Project:
The Ultimate Car Wash

Tramway Blvd.
Albuquerque, New Mexico

DRAINAGE AND GRADING PLAN
ULTIMATE CAR WASH

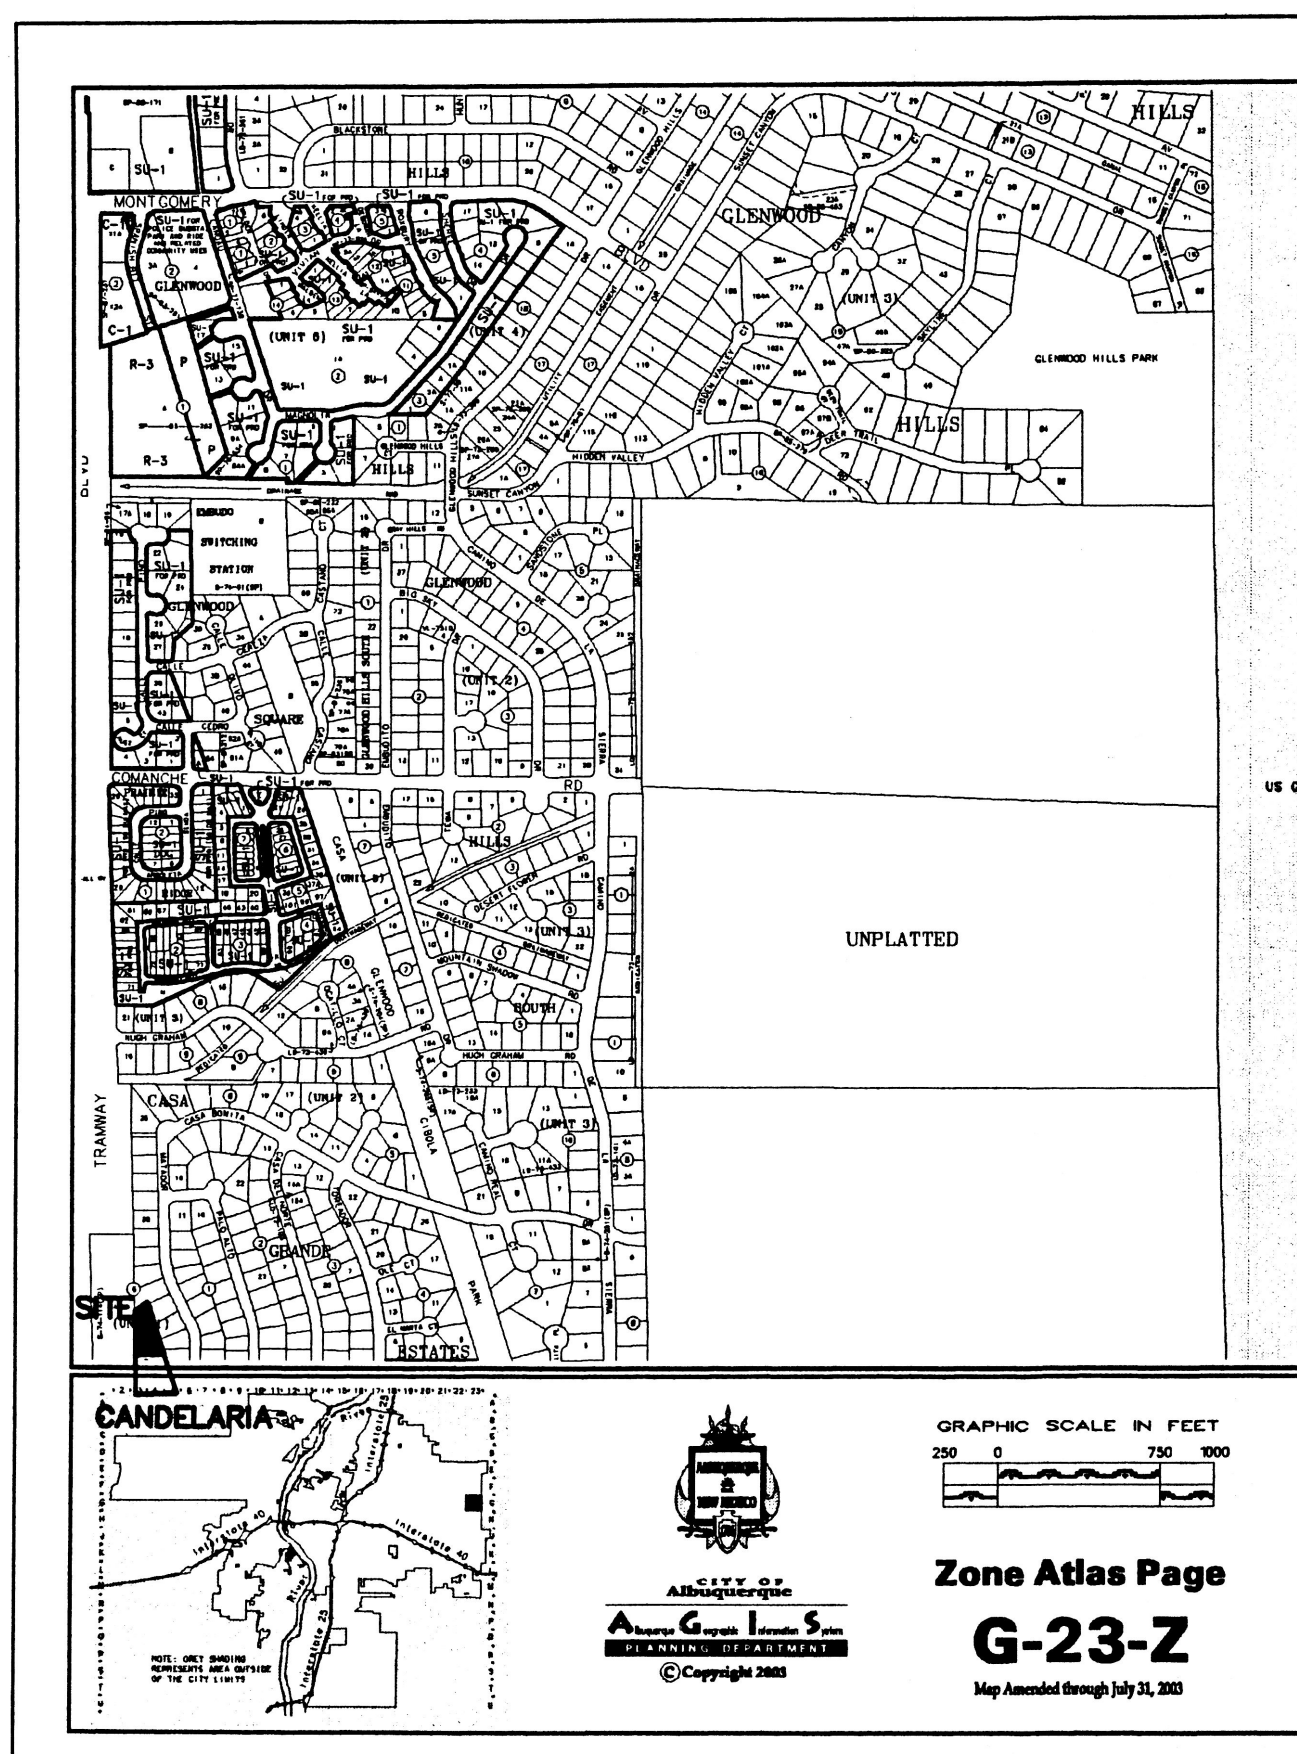
Need this easement prior to building permit approval!
- if being recorded by plat, provide a copy of the approved (by DRB) preliminary plat

There needs to be at least a 6" difference between the asphalt and top of wall elevation - provide a cross section

What does this hatching indicate?

Show the adjacent - must demonstrate how flow will reach Candelaria Rd - flow must be hardlined

DRAINAGE AND GRADING PLAN

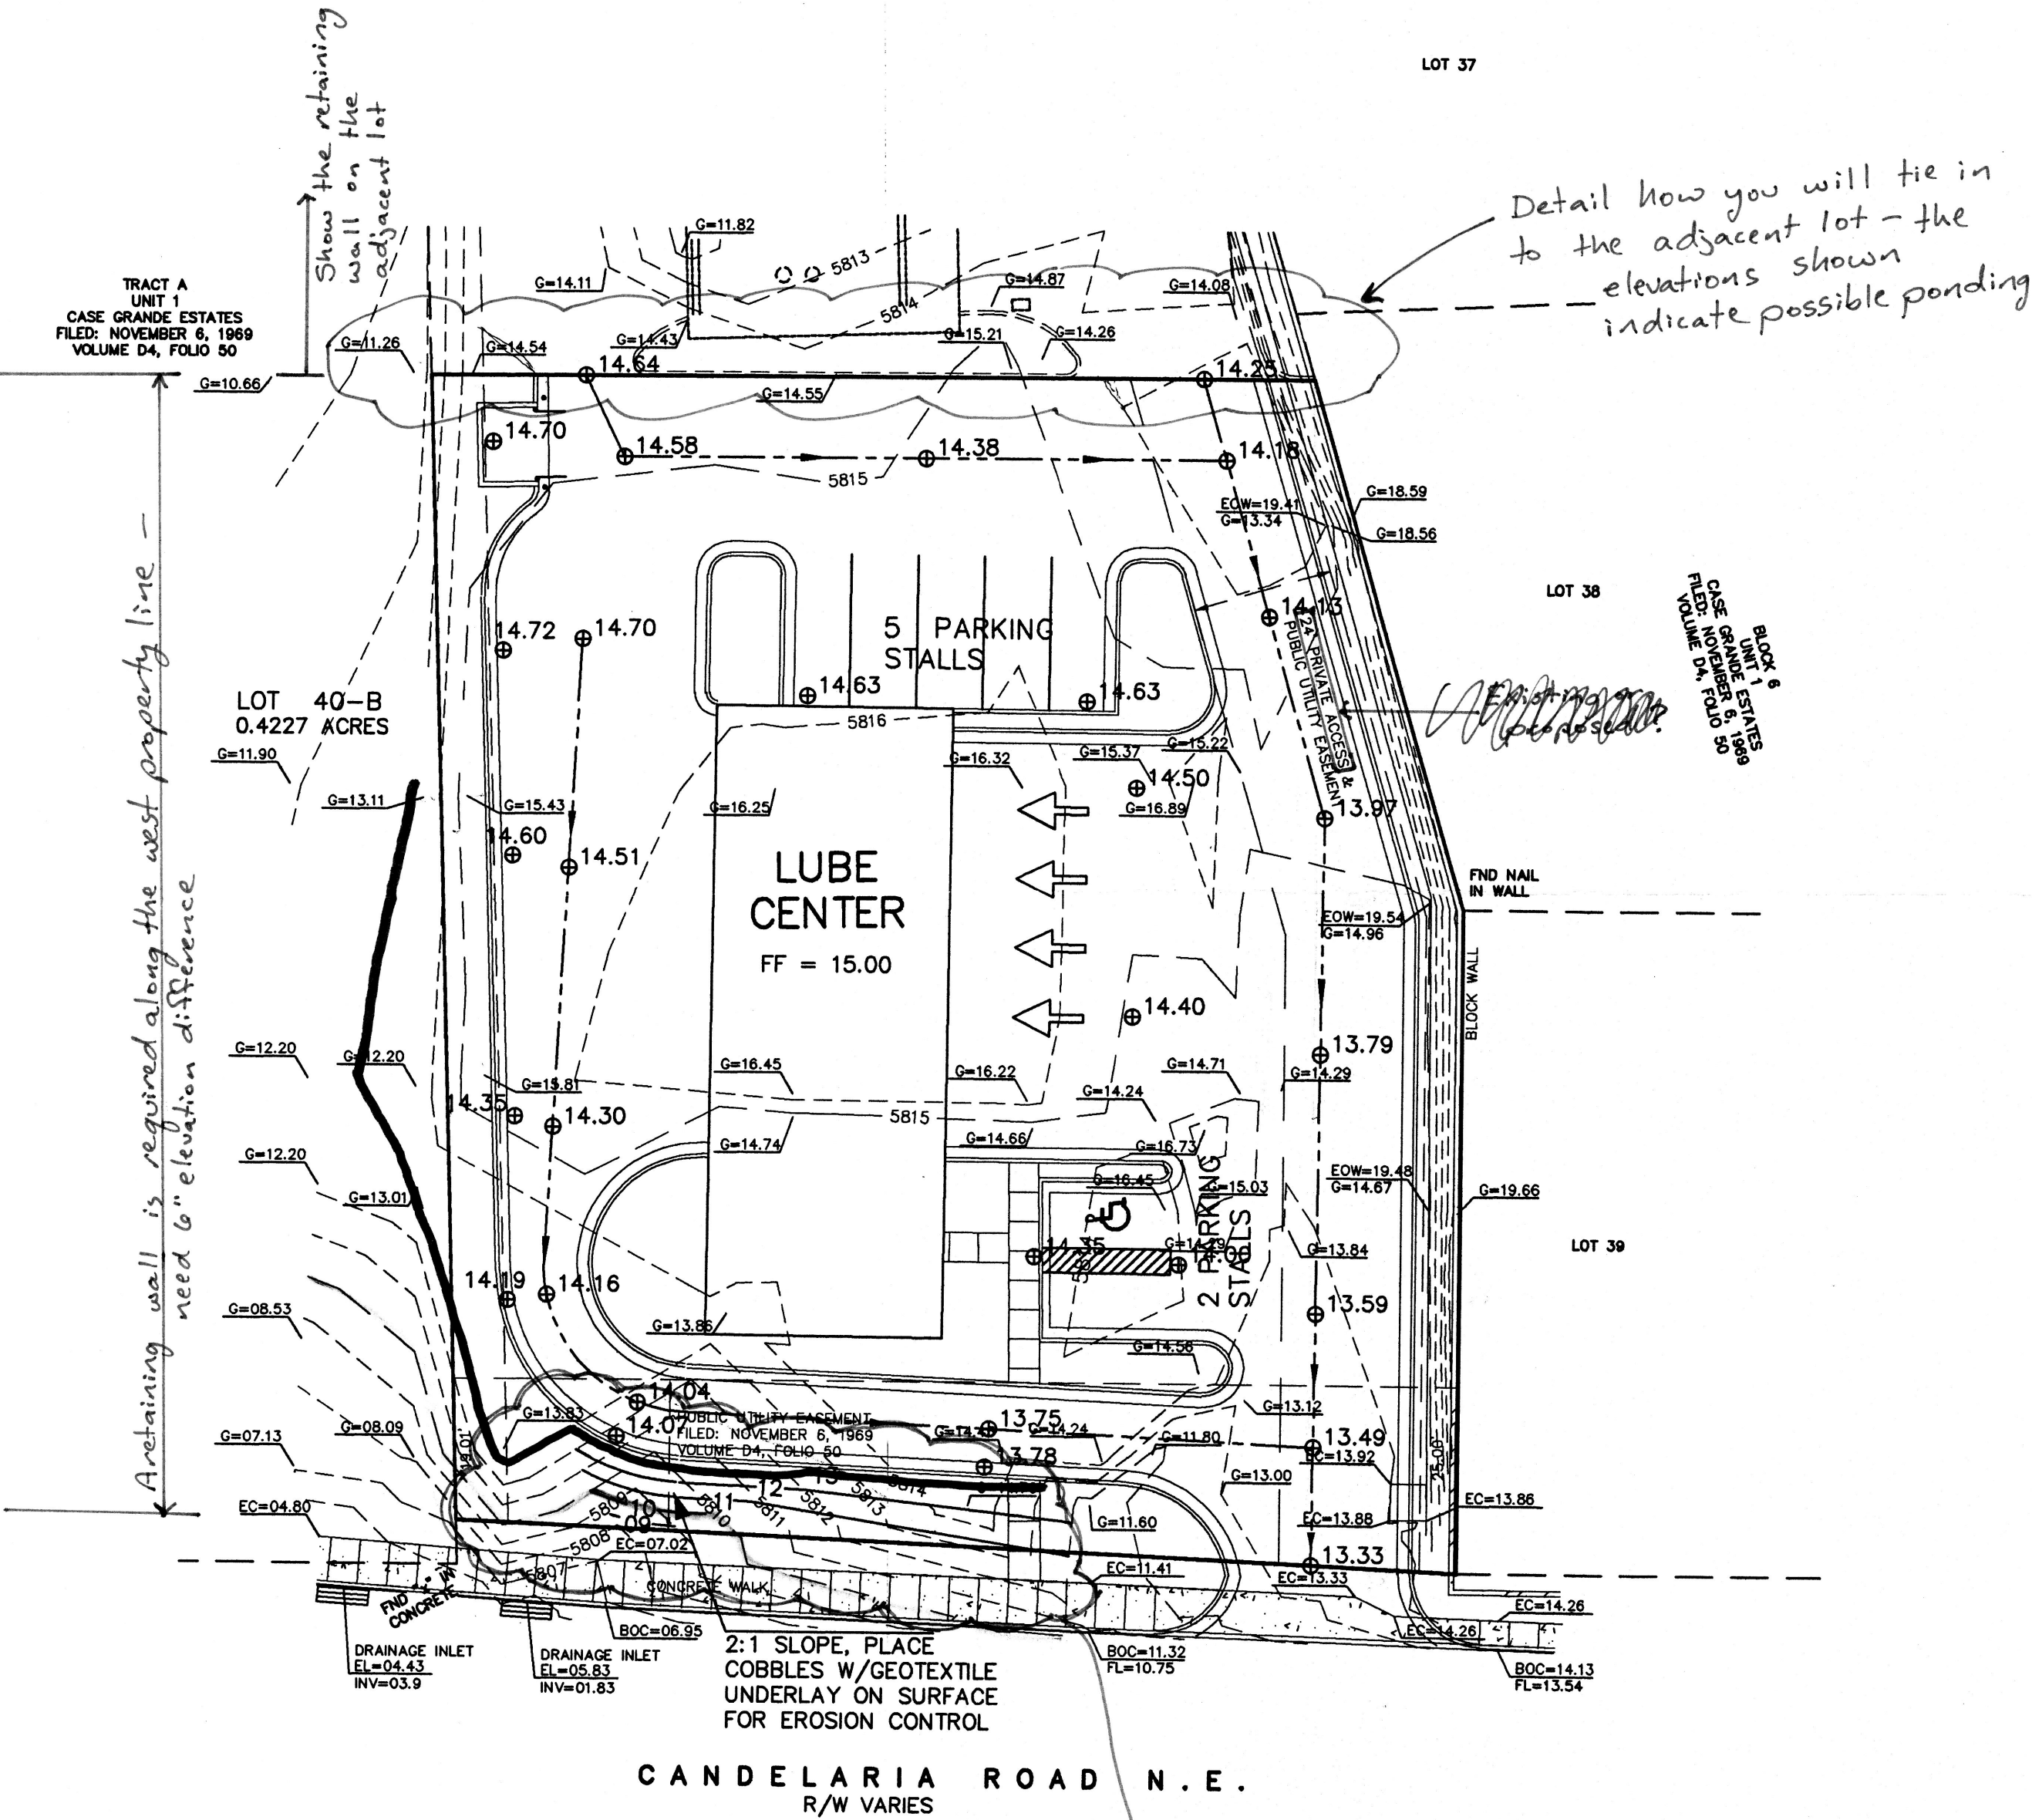
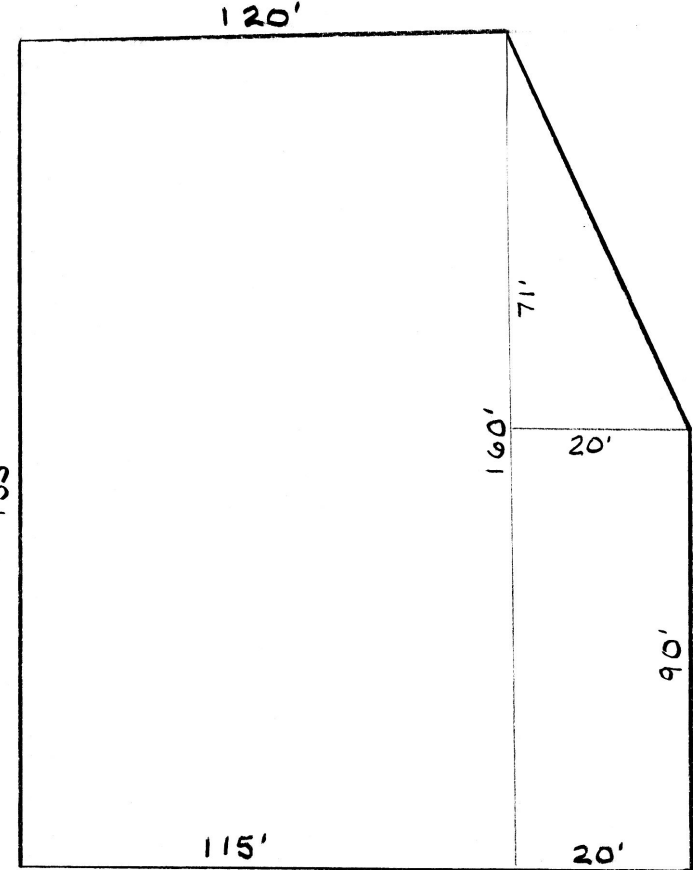
These calcs appear to be for the lot to the north - area of this site is approx 20700 ft²

Show where the offsite flow enters the site

Area ≈ 20700 ft²
